Application by National Grid Electricity Transmission (NGET) for a Development Consent Order (DCO) for the proposed Norwich to Tilbury Project (Application Reference: EN020027)

Norwich to Tilbury Project - Procedural Deadline 5 Response from Chelmsford City Council (CCC) Host Authority reference [REDACTED]

The Examining Authority’s written questions and requests for information (ExQ2): Issued on Friday 22 May 2026

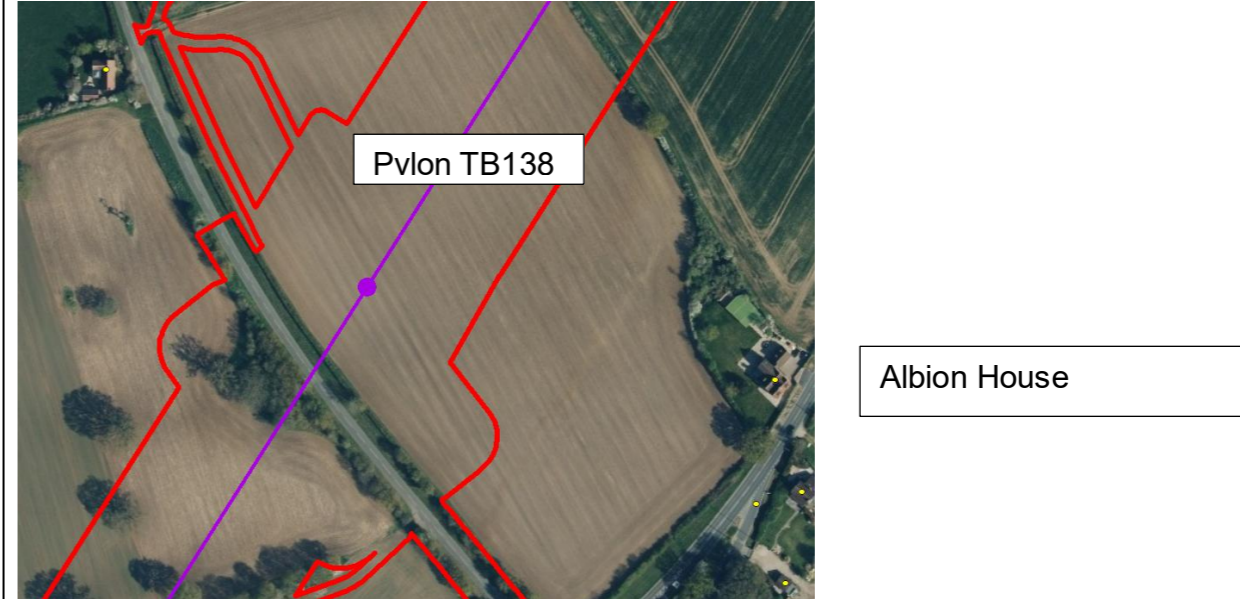
CCC do not consider the use of T-pylons has been adequately explored by the Applicant. T-pylons have a simple and elegant form, as well as a lower height, which is considered to reduce their impacts. Whilst permanent maintenance tracks are required, overall the impact is still considered to be reduced.
HE 2.3	The applicant	<p>Grouping of heritage assets</p> <p>The applicant's answer to ExQ1 HE1.8 [REP3-074] confirms the approach taken to harm caused to heritage assets and in particular notes the approach taken where the significance of individual assets is informed by its relationship with other assets, using the example of the Roydon Hall complex.</p> <p>Comments regarding the 'density' of heritage assets in the applicant's answers to the Historic Environment Rule 17 letter points 1 and 4 are also noted [REP4-318].</p> <p>The applicant is asked:</p> <p>a) Has any consideration been taken of wider groupings – for instance groups of heritage assets within Ardleigh, Ford Street or Great Waltham?</p> <p>B)Could relationships between assets, whether functional such as the Vicarage and Church in Ardleigh, or locational through shared ages and architectural styles specific to the locality raise the importance of the whole rather above the individual level? If so, how might this be affected by the proposed development?</p>	CCC consider the groups of vernacular buildings in Great Waltham and Little Waltham set within a rural setting have a group value and the harm to their settings is therefore magnified. This is also the case for the non-designated WWII defences at Great Waltham, which are bisected by the proposed route.

View South West along Chelmsford Road towards pylon TB141.

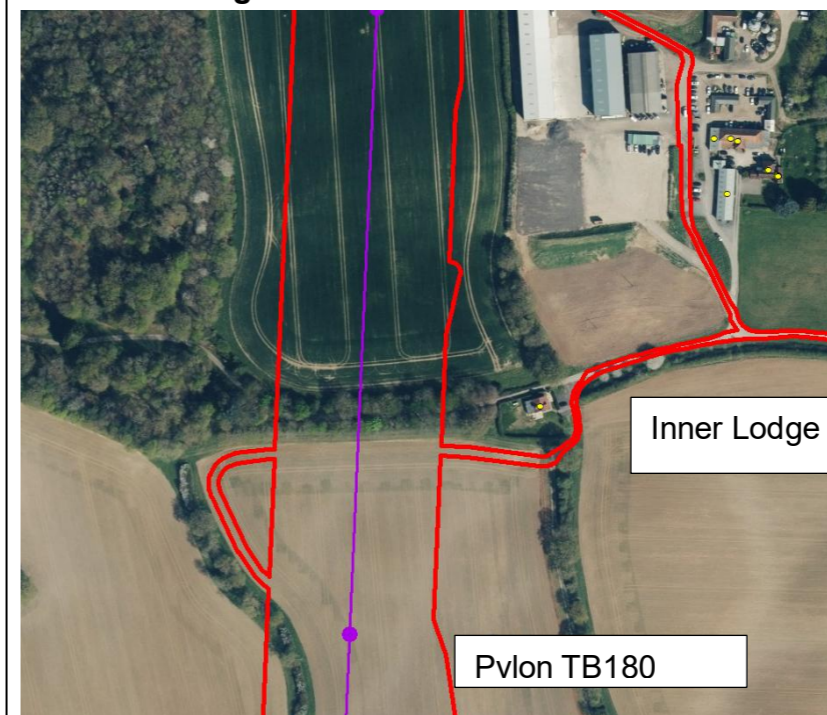
Although the movement of TB141 is welcomed in principle on amenity grounds, CCC maintain its position that a 45 metre high pylon would be visible from both ground and upper storey elevations due to its height.

As shown on the following photographs, the landscape surrounding Windmill House is open, with limited landscape screening, meaning that visibility would be high, with limited filtering from screening. The pylons would be visible within the streetscene and from views along the CCC Chelmsford Road. CCC maintains a stage 4 assessment should be undertaken.

CCC disagrees that the Project “would not have such an unpleasant, overwhelming or unavoidable effect on the views that the effect on visual amenity would be unacceptable” and considers that the effects experienced by affected receptors would not be perceived to be acceptable.

The pylons as permanent, motionless industrial features would not be perceived by surrounding receptors to be visually permeable structures, and would be noticeable and prominent in the undeveloped, open views from Windmill House.
